PCN-20190430 TE0714-02-* to TE0714-03-* Hardware Revision Change

Company	Trenz Electronic GmbH
PCN Number	PCN-20190430
Title	TE0714-02-* to TE0714-03-* Hardware Revision Change
Subject	Hardware Revision Change
Issue Date	2019-07-15

This change affects all Trenz Electronic TE0714-02 SoMs: TE0714-02-*

#6 Optimized testpoints placement

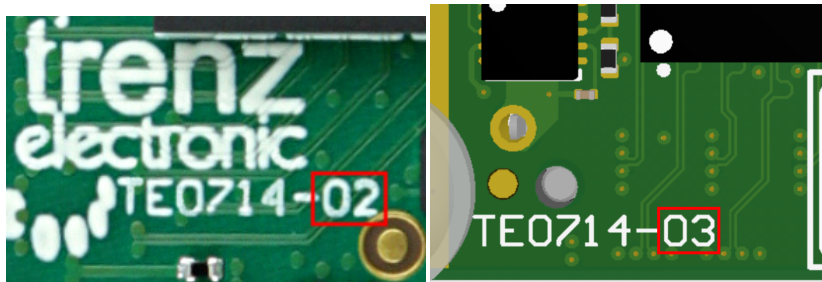
Type: PCB change

Reason: Prepare for automated testing

Impact: None
